**Application: 20230797**  
**Your Reference: EDC/23/0096**

**NO OBJECTION TO GRANT OF PERMISSION TO DEVELOP LAND**

and being **EDC Consultation EDC/23/0096 - Reserved Matters Application (matters relating to access, layout, scale, appearance and landscaping) pursuant to condition 2 of outline planning permission reference no. EDC/16/0004 for the employment land at Church Path Pit comprising the erection of industrial and logistics units (Use Classes E(g)(iii) and/or B2 and/or B8) with ancillary office accommodation, external yards areas, staff and operational vehicle parking, servicing and associated works.**

There is a drainage map that shows open storage sites 1, 2 and 3, which includes a high level crate in site 1:

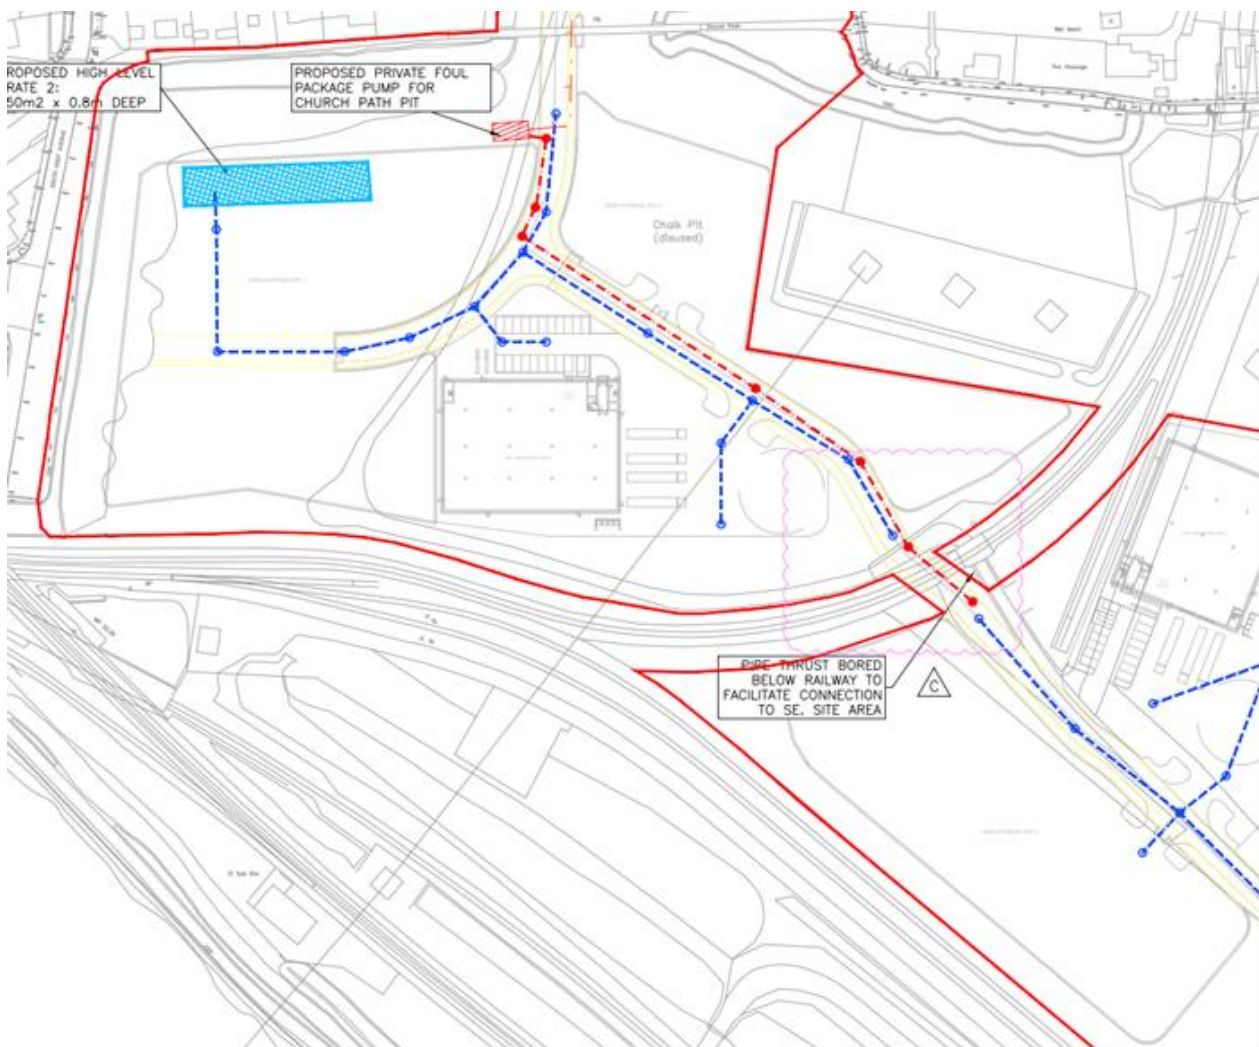
There appears to be very little information about the Chalk Path Pit development including the open storage which is only shown hatched in blue on the illustrative masterplan, but with no further details.

From the submitted documents, there are only air quality and noise impact assessments for Triangle Site and Vineyard Pit Employment Lane. The open storage in Church Path Pit does not appear to have been considered.

Therefore the Local Authority raise concerns over the amount of open storage (just over two hectares), it's location, how it is to be used and the overall impact, which does not appear to have been assessed fully from the submitted details.
